**Re: FortisBC Energy Inc. (FEI)**

**Application for a Certificate of Public Convenience and Necessity (CPCN) for the Tilbury Liquefied Natural Gas Storage Expansion (TLSE) Project (Application)**

**Response to the Commercial Energy Consumers Association of British Columbia (CEC) Information Request (IR) No. 5**

Figure U.44. Expected annual winter-only GDP loss in million CAD per year for T-South (AV-1, -2, -3, and -54) for the Tilbury Alternatives.

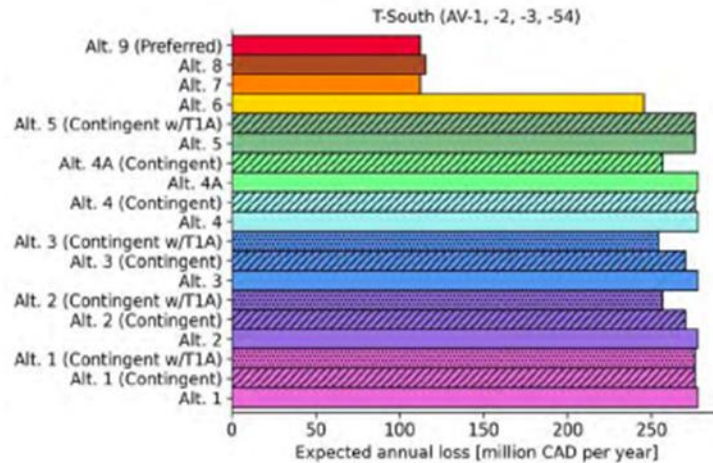
117.6 Please confirm, or explain otherwise, that Figure U.44. provides the residual risk of winter-only GDP loss following implementation of the various Tilbury Alternatives. For example, the residual risk of winter-only GDP loss following implementation of Alternative 8 is approximately \$115 million.

Figure U.50. Expected 67-year winter-only GDP loss in million CAD for T-South (AV-1, -2, -3, and -54) for the Tilbury Alternatives.

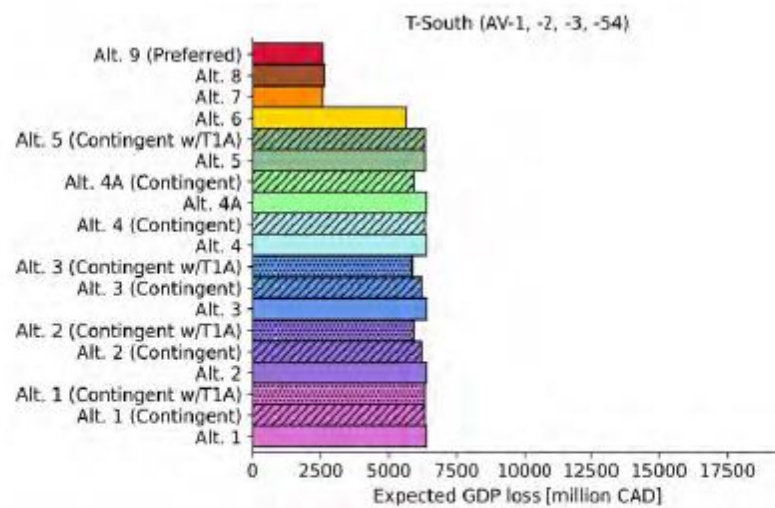
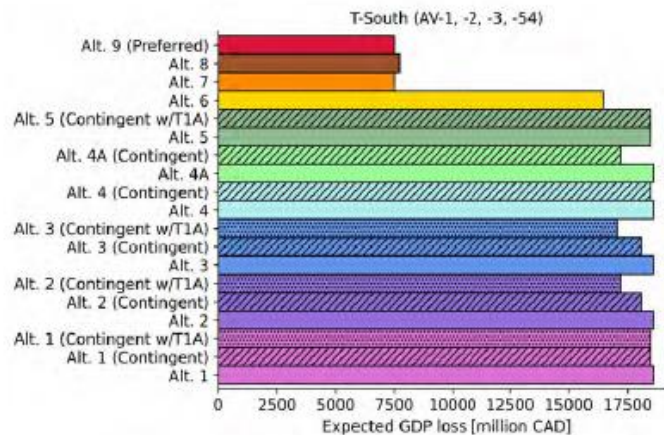
137.5 Please confirm that the \$18.6 billion Expected GDP loss for 67 years is depicted in Figure U-50 and not Figure U-47 as written on page U-80, pp 105.

3    That is correct – the reference at U-80, para. 105 should be to Figure U-50.

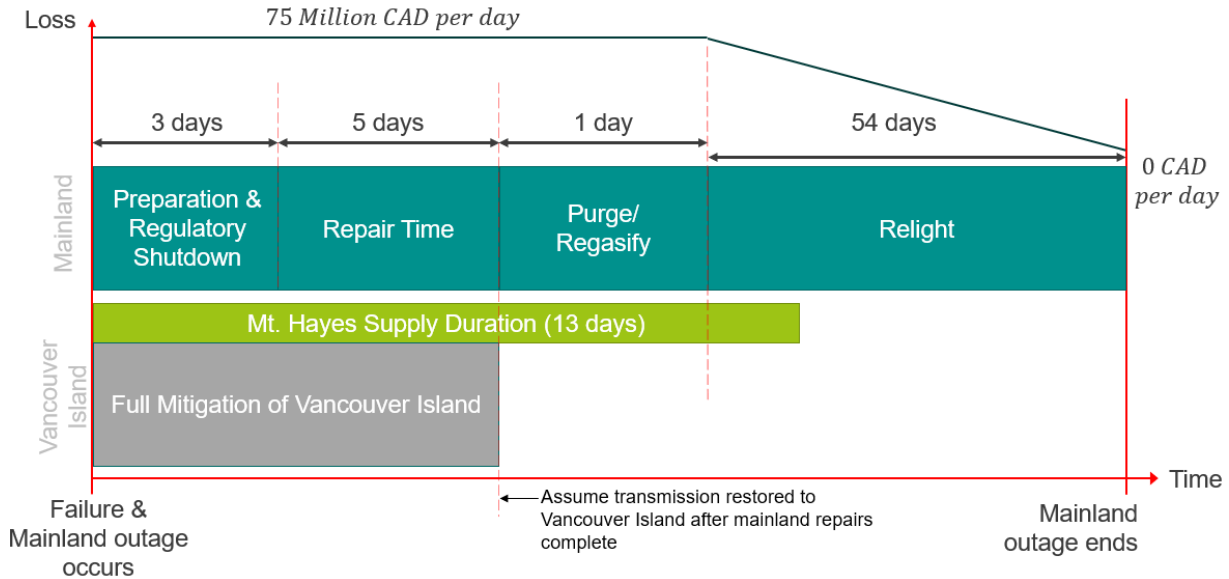
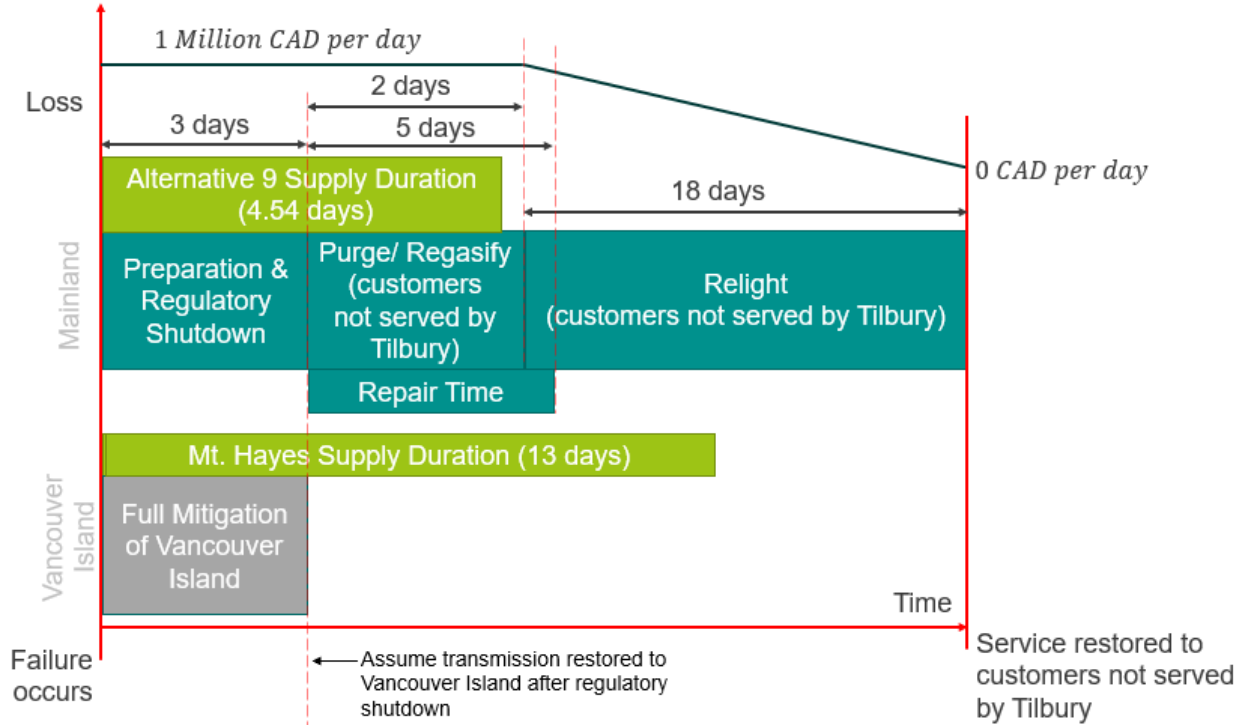
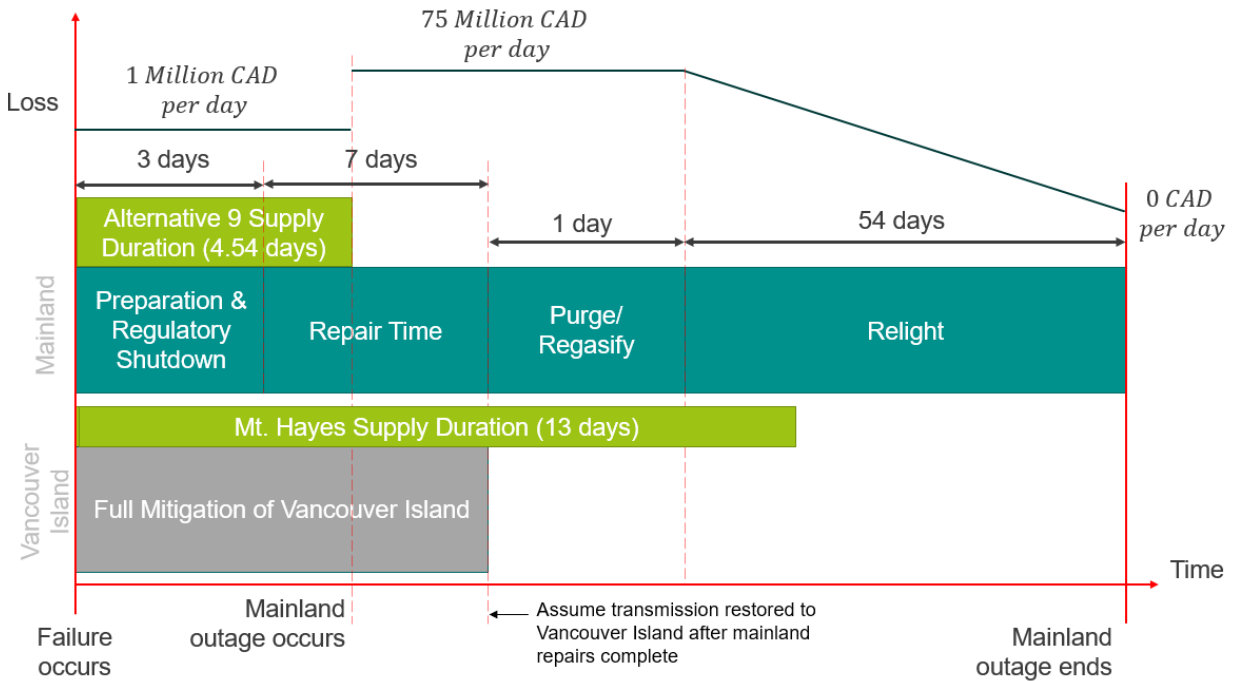
2  
3        138.1 Please provide the GDP impacts for the T-South No-Flow event in winter based  
4            on GDP loss derived from loss of supply by customer class (industrial,  
5            commercial, and residential) and show the loss impacts by day over the duration  
6            of the lack of supply and show the daily supply recovery by day over the same  
7            time frame (please use year 23 and 67 as the years for the specific T-South No-  
8            Flow event).

15    To determine expected GDP losses, Exponent performed a Monte Carlo analysis, which  
16    produced many realizations of no-flow events, each with different simulated recovery times,  
17    dependent on, among other things, the repair time, which will differ for each simulation. The loss  
18    impacts by day also vary depending on whether the no-flow event impacts both pipes or a single  
19    pipe, which depends on the realization, as well as the precise mitigation scenario considered. The  
20    calculations for total losses corresponding to different no-flow scenarios are provided in Appendix  
21    U to the Exponent Report. Exponent cannot reasonably provide the loss impacts by day for all  
22    realizations, but provides the below examples of loss impacts by day over the duration of an  
23    outage event.

24    The figure below illustrates how daily GDP loss for AV-1 varies after a failure that requires five  
25    days to repair. AV-1 has a controlled shutdown, resulting in the 1-day purge/regasify period and  
26    54-day relight period. Because Mt. Hayes provides 13 days of backup supply to Vancouver Island  
27    – which is supplied under normal circumstances by AV-1 – no outage occurs on Vancouver Island,  
28    and so there is no associated loss from Vancouver Island.

2 The figure below illustrates how daily loss varies with time elapsed after a failure on one of the

- 1
- 2 The below figure shows how daily loss evolves after a failure of both pipelines within AV-1.
- 3 Because both pipelines are damaged, customers on the mainland not served by Tilbury
- 4 experience an immediate outage. The remainder of customers on the mainland don't experience
- 5 an outage until the backup supply from Tilbury is exhausted, at which point a full outage on the
- 6 mainland occurs while repairs on the damaged pipes continue. No outage occurs on Vancouver
- 7 Island because Mt. Hayes has a backup supply that lasts longer than the combined Preparation
- 8 & Regulatory Shutdown and Repair Time. Therefore, no losses occur on Vancouver Island.

**Figure 1: YVR Daily Mean Temperature for December 2022 vs. FEI Analysis Temperature Pattern**

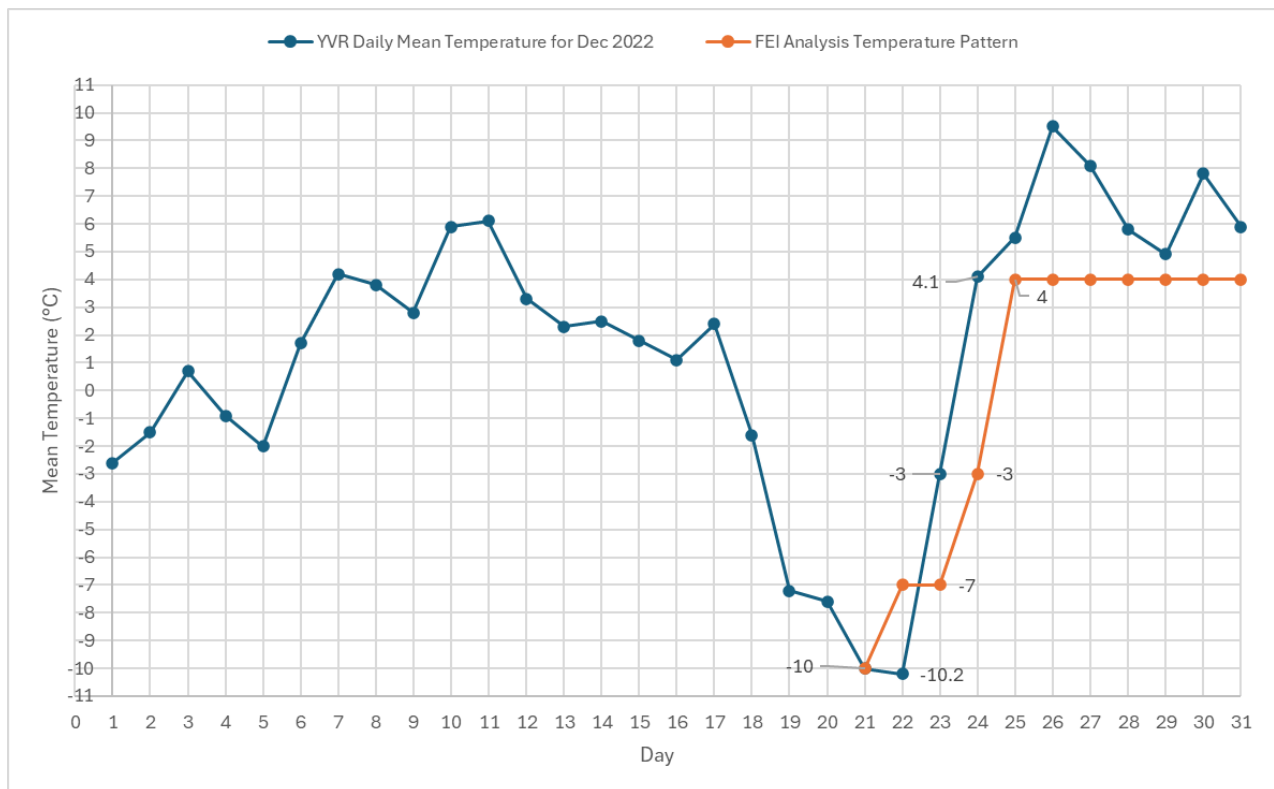
141.4 Please confirm that if FEI assumes that low temperature winter days are all described by -10°C for the first day -7°C for the second and third days and -3°C for the fourth day, followed by +4°C for the remaining days, such assumption may not be a correct representation of the past experience but is assumed for convenience of analysis.

FEI based the temperature pattern used for the “very cold Lower Mainland winter day” on a cold snap that occurred from approximately December 18 to December 24, 2022.

Figure 1 below plots the actual mean daily temperatures at YVR in December 2022 versus the assumed pattern used for FEI’s analysis. As the figure demonstrates, the assumed pattern follows the trend of the actual temperatures that occurred during the cold snap. In the analysis, FEI assumed that the rupture incident occurs near the peak of the cold snap and, therefore, replaced the  $-10.2^{\circ}\text{C}$  temperature condition that occurred on December 22 with a more conservative assumption of two consecutive days of  $-7^{\circ}\text{C}$ . FEI made this substitution due to the low likelihood of having consecutive  $-10^{\circ}\text{C}$  days. While consecutive  $-10^{\circ}\text{C}$  days occurred in this cold snap, based on the YVR temperature dataset going back to 2008, this is the only occurrence of multiple consecutive  $-10^{\circ}\text{C}$  or colder days.
